**DRAINAGE REPORT
QUAIL & COORS
QUAIL ROAD N.W. & COORS ROAD N.W.
CITY OF ALBUQUERQUE, NEW MEXICO**

REVISED FEBRUARY, 1992

RE: REVISED DRAINAGE PLAN FOR DIAMOND SHAMROCK, INC. @ COORS &
QUAIL, NW (H-11/D39) REVISION DATED MAY 12, 1992

RE: DRAINAGE PLAN FOR DIAMOND SHAMROCK, INC. @ COORS &
QUAIL, NW (H-11/D39) ENGINEER'S STAMP DATED
JANUARY 21, 1992

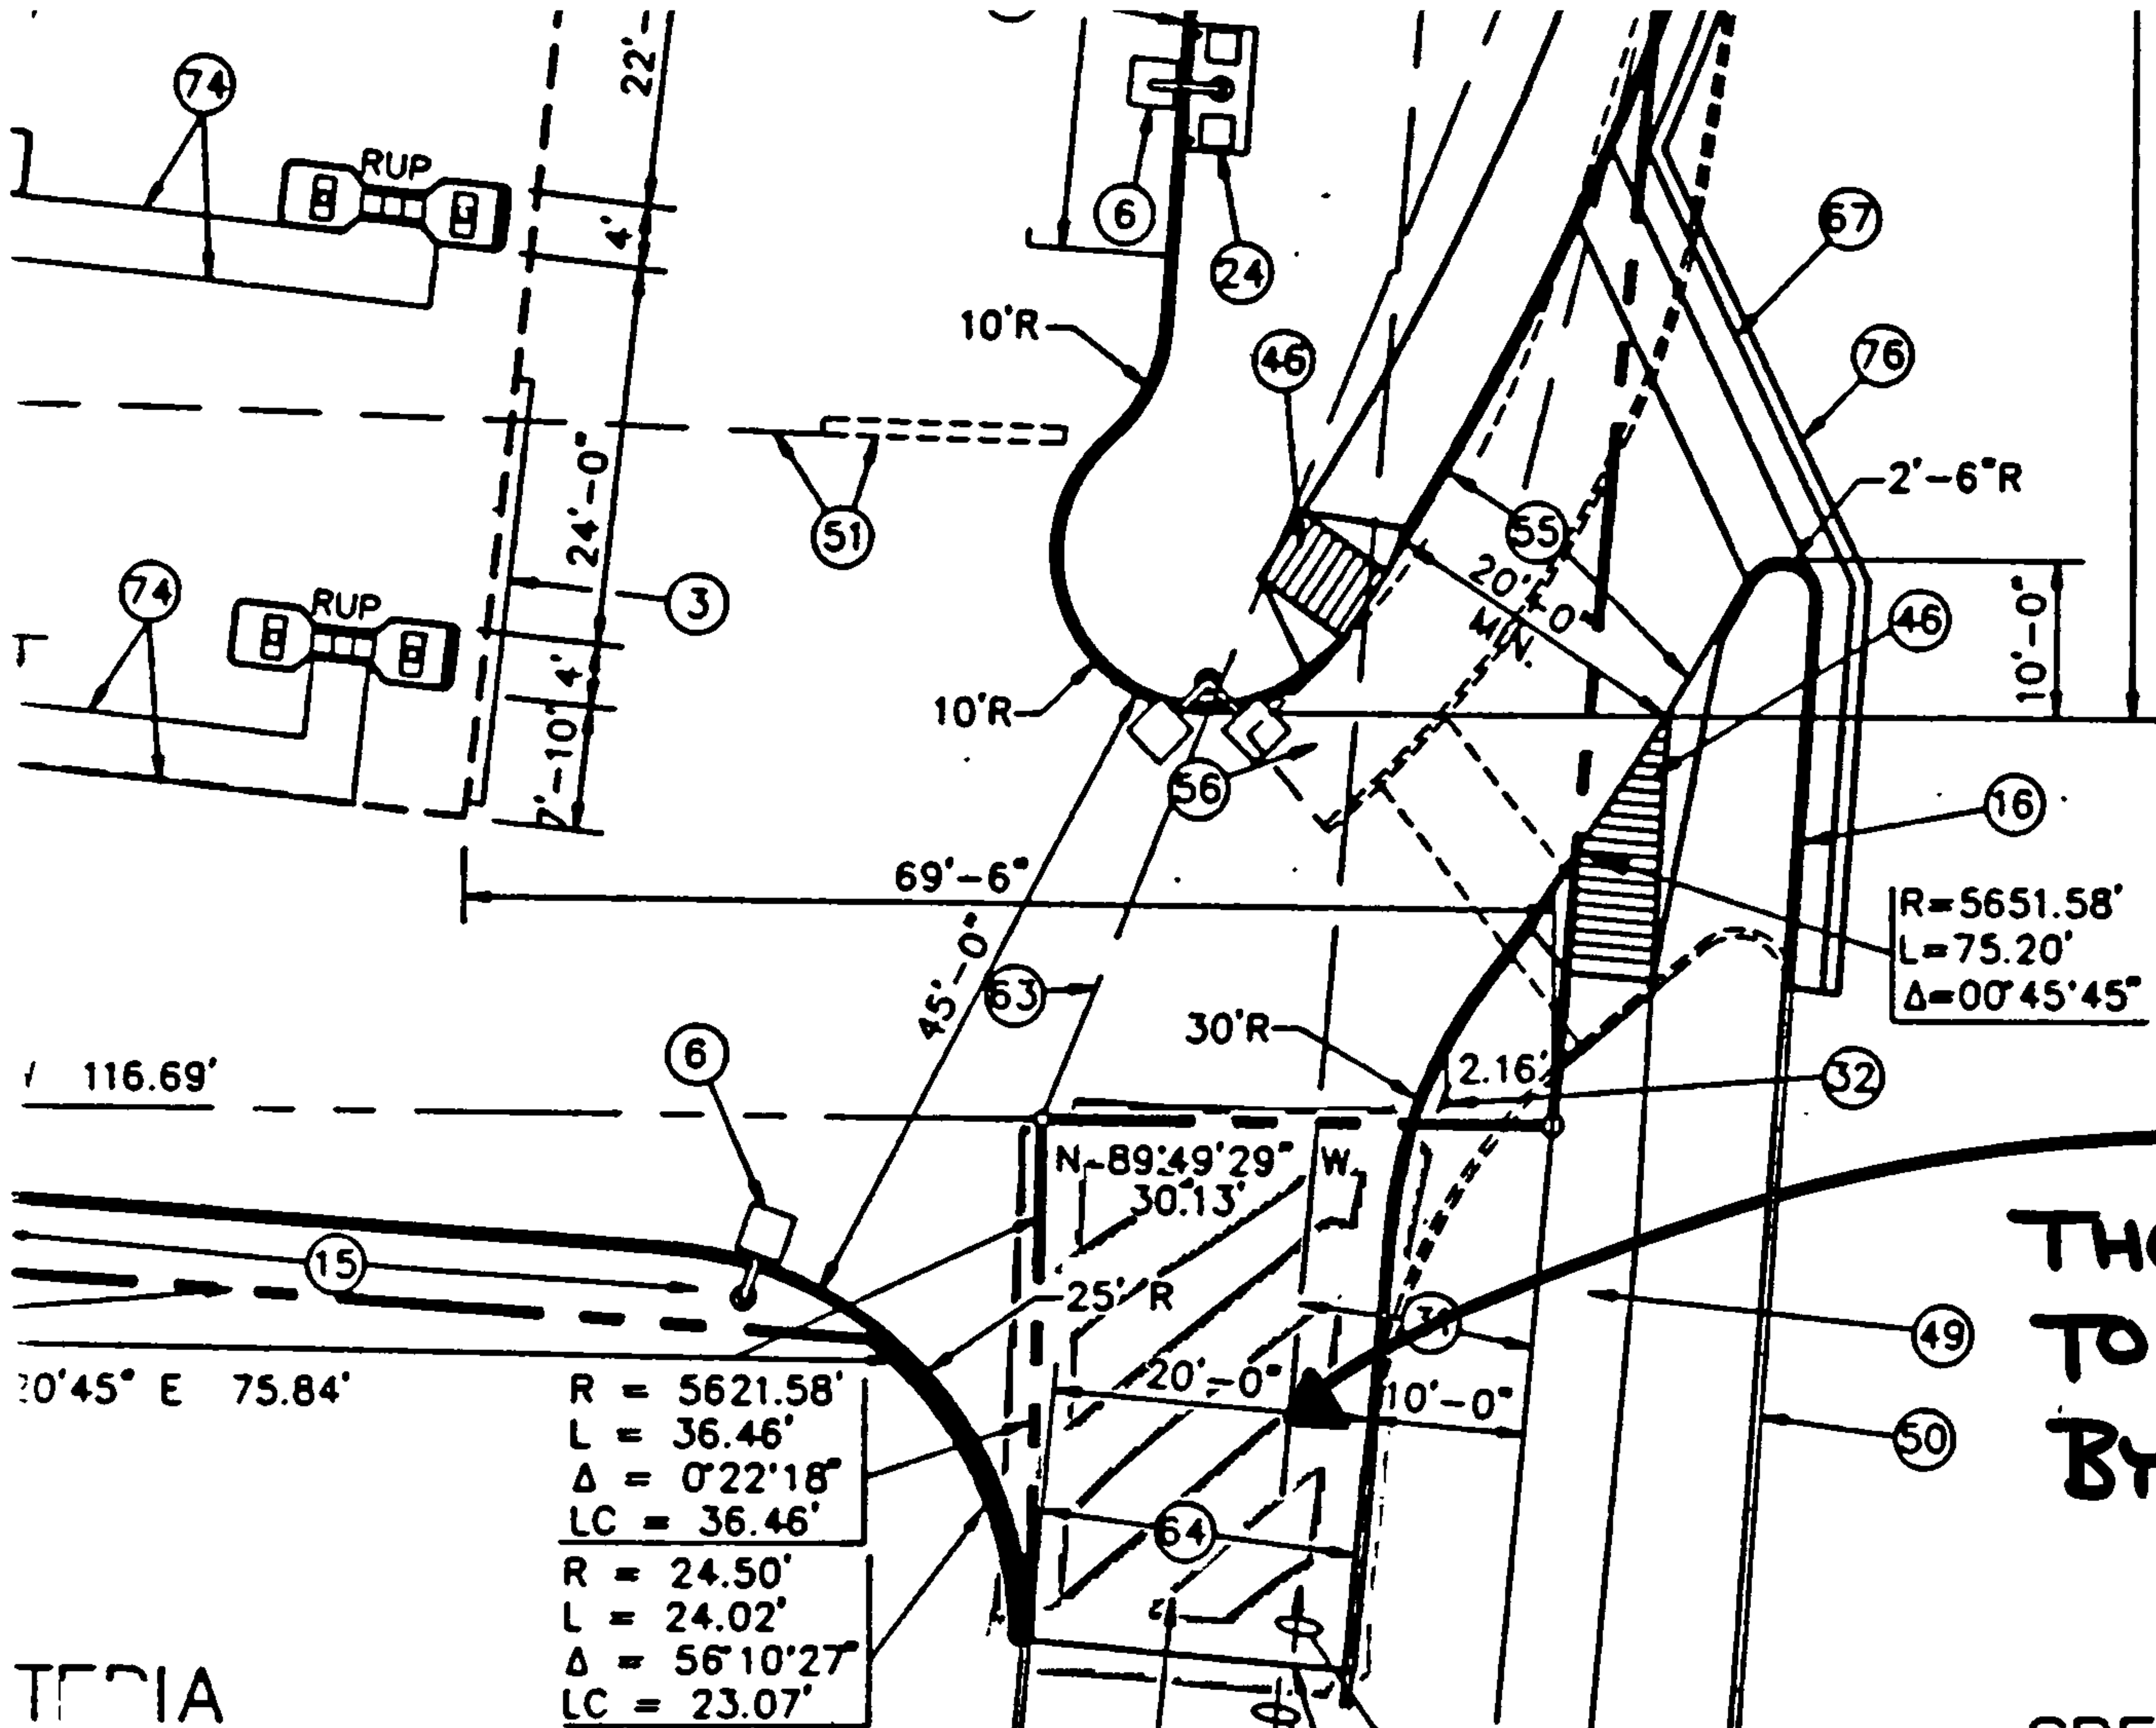
Based on the information provided on your submittal of January 21, 1992, listed are some concerns that will need to be addressed prior to final approval.

1. Your plan drawing indicates some work being proposed on the adjacent property to the south. We will need concurrence from the owner.
2. T.B.M. must be permanently marked.
3. Notation on plan that the roof drains from the car wash must be routed towards the asphalt.
4. Please include the hydraulics for the proposed inlet and pipes. Also, indicate the flow rate entering the proposed inlet.
5. On your resubmittal, submit only two copies of (SP-3). I do not need the report. You can add the hydraulics on the plan drawing.
6. Engineer's Certification will be required prior to release of Certificate of Occupancy. A field trip by someone from your company is required and not just the as-built information from the contractor is adequate for Certification.

I am enclosing a copy of a portion of the Diamond Shamrock site plan. The area shaded yellow is the portion of Tract A-23-1-A which Diamond Shamrock proposes to improve with pavement. The shaded area is also a portion of the access road shown on the plat.

We have been informed by Ken Baca of Diamond Shamrock of their need to pave this area and do hereby consent to the excavation and construction of paving thereon by Diamond Shamrock, their contractor, or assigns.
